Subject: UniStar Nuclear Energy, NRC Docket No. 52-016
Submittal of Response to Calvert Cliffs Nuclear Power Plant, Unit 3
COLA, Request for Additional Information Terrestrial Ecology

Response to Terrestrial Ecology RAIs

**500' Buffer of the Chesapeake Bay Bluff Habitat That Is Utilized By
Tiger Beetles**

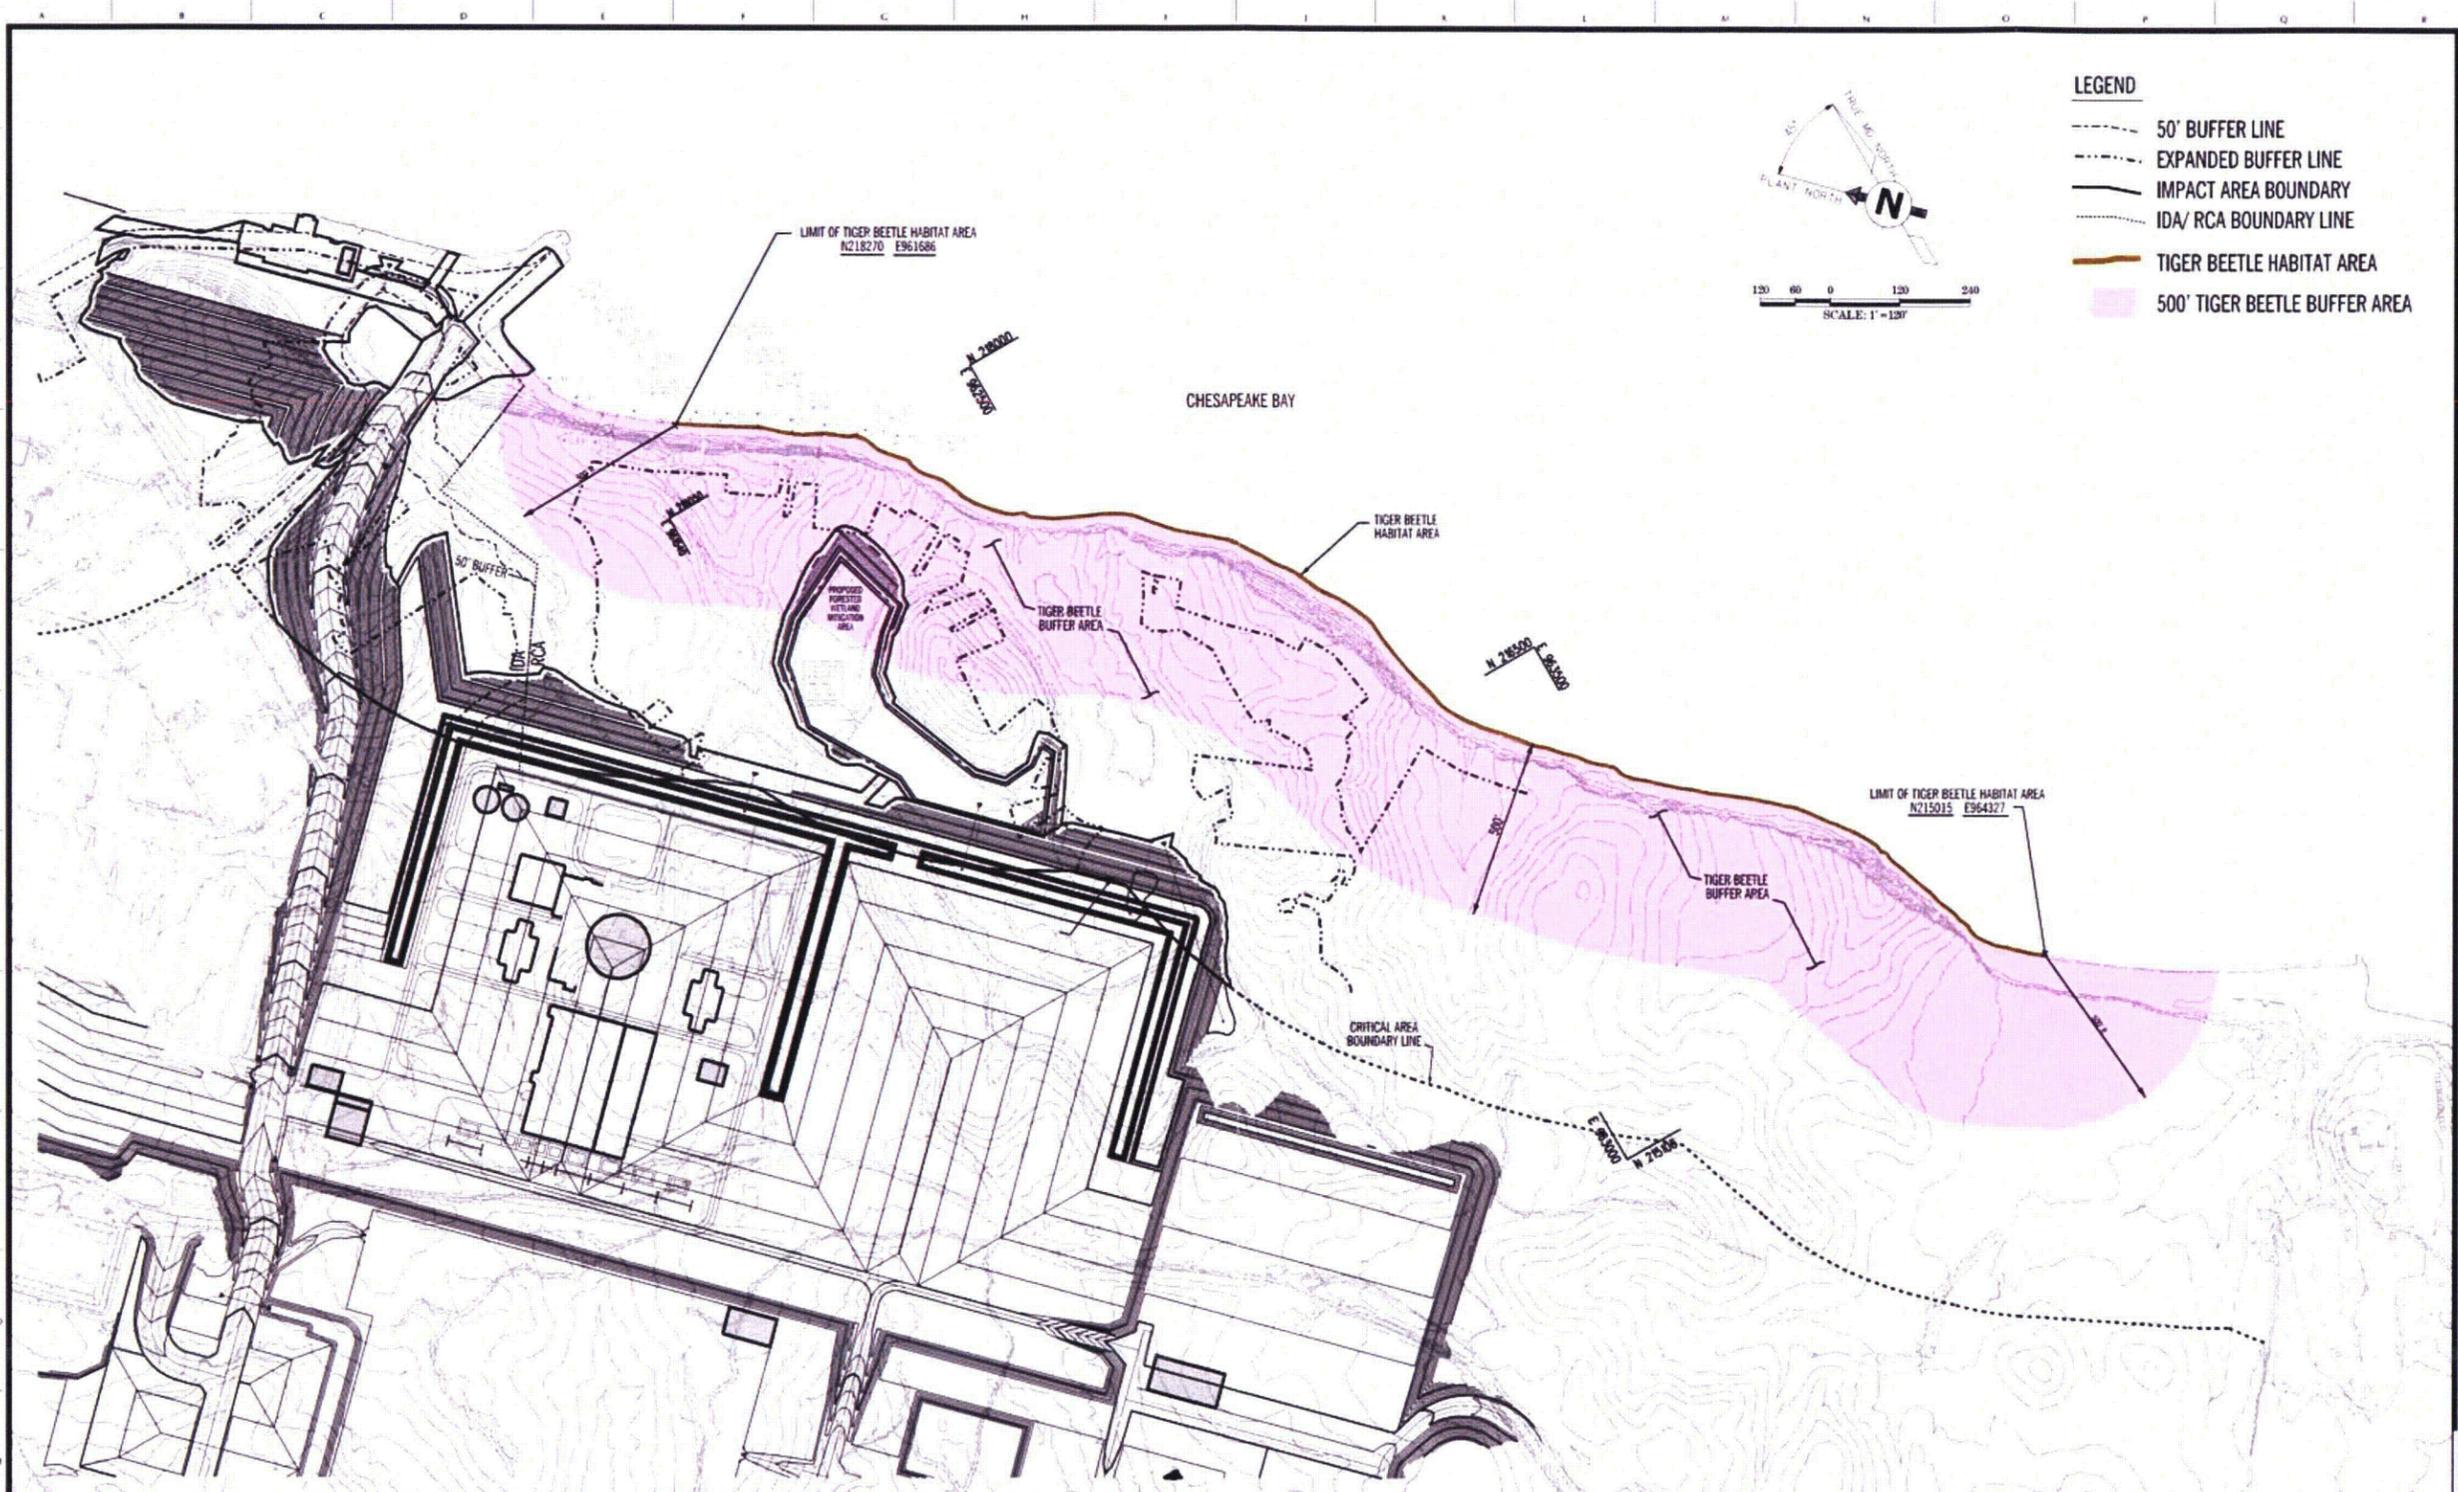
Provide a figure (e.g., a map) illustrating the 500' buffer of the Chesapeake Bay bluff habitat that is utilized by tiger beetles, and any encroachment within the buffer due to activities associated with proposed Unit 3.

Attachment 3 to this response provides a map illustrating the 500' buffer of the Chesapeake Bay bluff habitat that is utilized by tiger beetles, and any encroachment within the buffer due to activities associated with proposed Unit 3.
